Subject: Response to EPA Comments for the Work Plan, Parcel C Treatability Study Dated October 22, 1997, Hunters Point Shipyard, San Francisco, California

**Amendment A**

**Response to EPA Comments  
Hunters Point Shipyard, Parcel C, Treatability Study  
Dated October 22, 1997**

**Figure 2**  
**SOIL VAPOR EXTRACTION / AIR SPARGING**  
**PILOT TEST LAYOUT AT RU-2**  
**PARCEL C TREATABILITY STUDY**

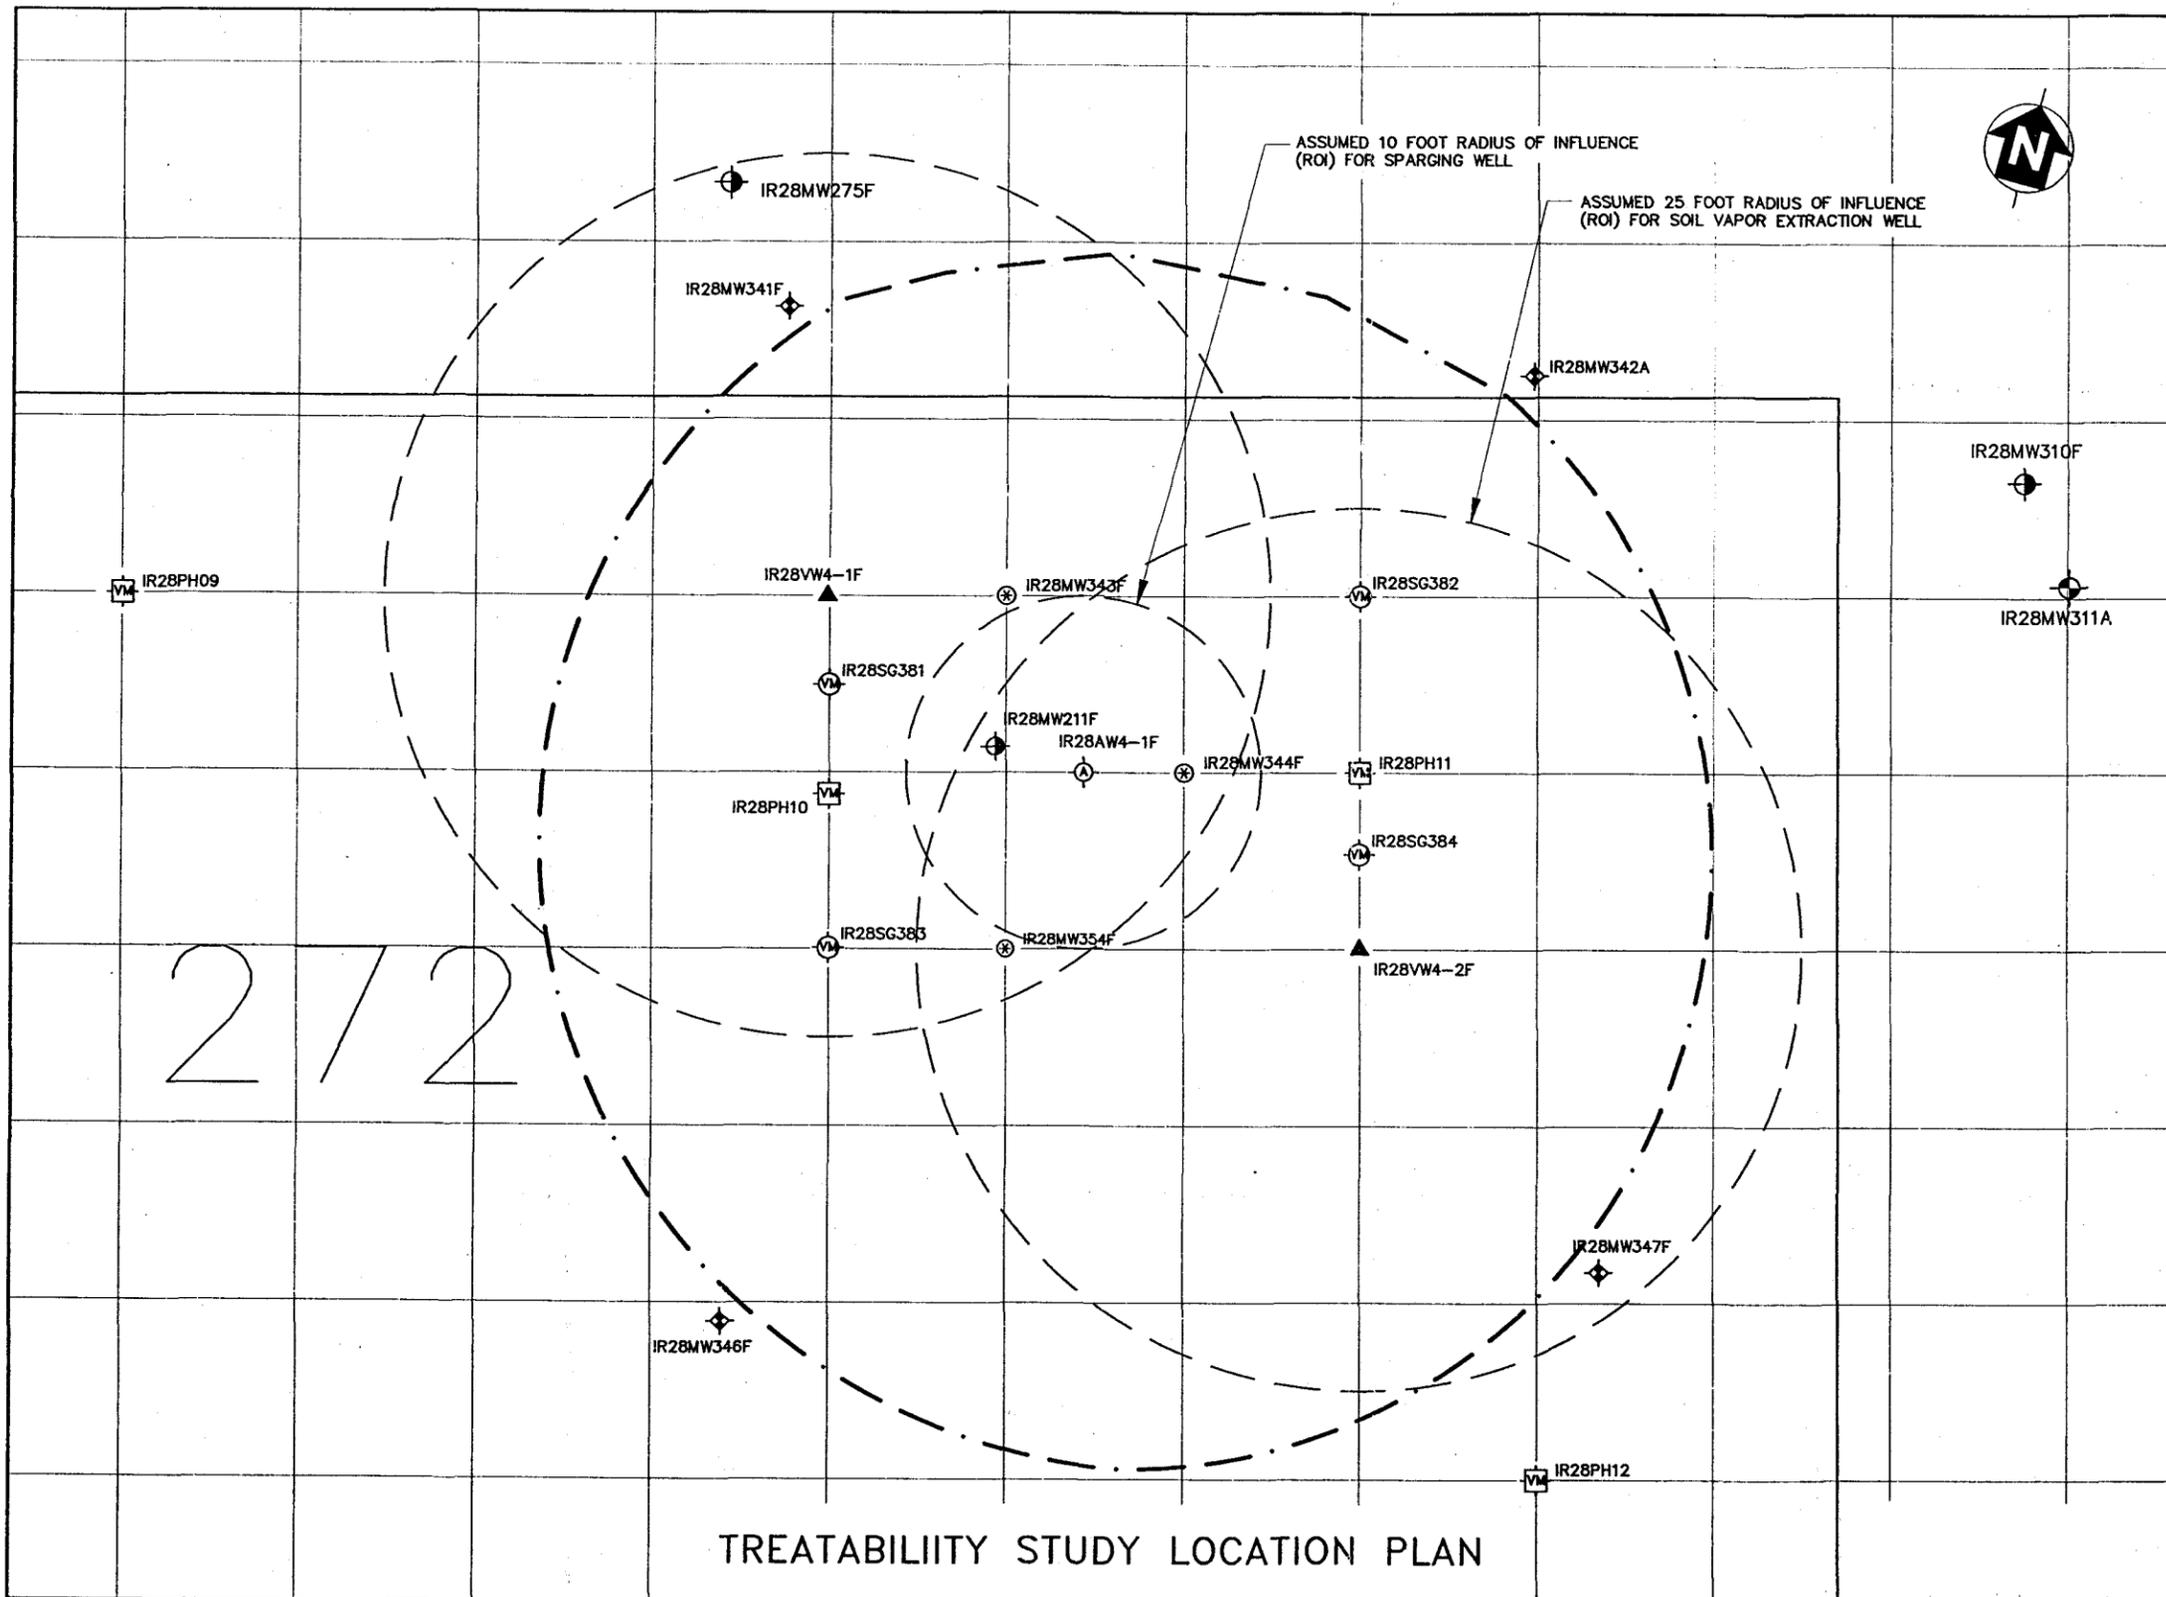
**Comment:** Section 3.3.1, Page 6, Paragraph 2. The text states that the spacing of the soil vapor probes is based upon the estimated radius of influence (ROI) of the SVE vents. Please discuss the basis for the estimated ROI. Likewise please indicate the basis for selection of piezometer locations for monitoring air sparging.

**EPA suggests that an additional soil vapor probe at a distance of 5 or 10 feet beyond the expected ROI be added.**

**Response:** While the actual ROI of the SVE wells cannot be determined before performing the on-site pilot test, ROI estimates can be made based on published data obtained from other SVE tests conducted at similar sites. Using a steady-state radial flow solution for compressible flow, assuming an applied vacuum of approximately 0.2 atmospheres (less than 7 feet of water) and an average soil permeability of 1 darcy (the equivalent of a silty sand), then the estimated ROI would be approximately 30 feet. This estimated ROI is consistent with values published for relatively low-permeability soils (such as those at Parcel C) in U.S. EPA guidance documents (Guide for Conducting Treatability Studies Under CERCLA: Soil Vapor Extraction, September 1991). To ensure that there was an overlap in the coverage areas for each of the SVE wells, it has been proposed to install the wells on 25-foot centers at RU-4 and RU-6 and on 27-foot centers at RU-2 to prevent the escape of any sparged air and vapors.

**FIGURE 7**  
**LAYOUT OF SOIL-VAPOR SURVEY**  
**AT RU-2**  
**PARCEL C TREATABILITY STUDY**

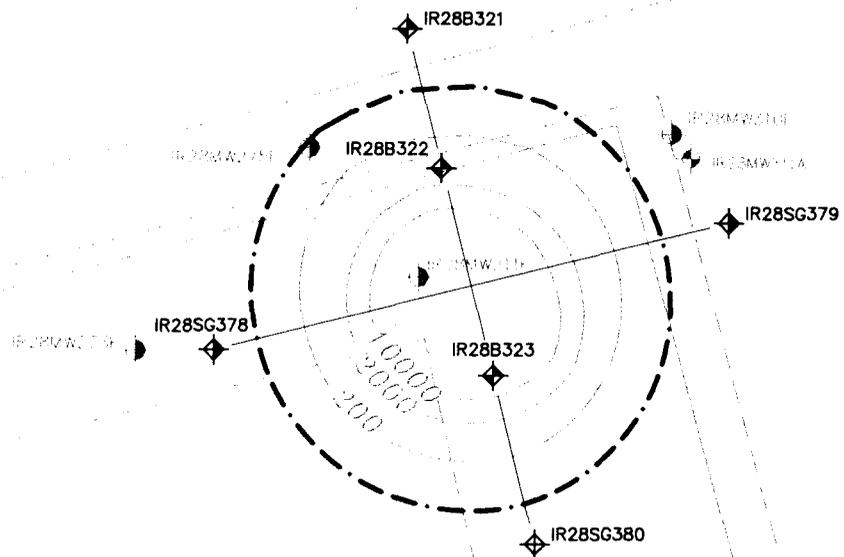
**Comment 6:** A vertical gas profile in the areas of concern analyzing for not only the contaminant constituents but also CO<sub>2</sub>, O<sub>2</sub>, and organic carbon needs to be done to refine the placement of the wells and determine where the gas is coming from. A similar situation at Alameda NAS found a gas restricting layer at about 1 meter which was not visible from the soil logs (Lawrence Berkeley Lab LBL-37768, UC-402 Nov 1995), but at Hunters Point we don't know if this type of layer exists.

**Response:** The soil-vapor survey was revised to include sampling over 2-foot intervals. Soil-vapor samples will be collected from 2, 4, 6, and 8 feet bgs at locations located along transects at RU-2, RU-4, RU-5, and RU-6 (see revised Figures 7 through 10 for locations). At the remainder of the locations, soil-vapor samples will be collected from approximately 4 feet bgs. All soil-vapor samples will be analyzed for CO<sub>2</sub> and O<sub>2</sub> in addition to VOCs. Soil samples will be collected from 2, 4, 6, and 8 feet bgs generally at alternate locations along the transects (see revised Figures 7 through 10 for locations); the soil samples will be analyzed for total organic carbon.
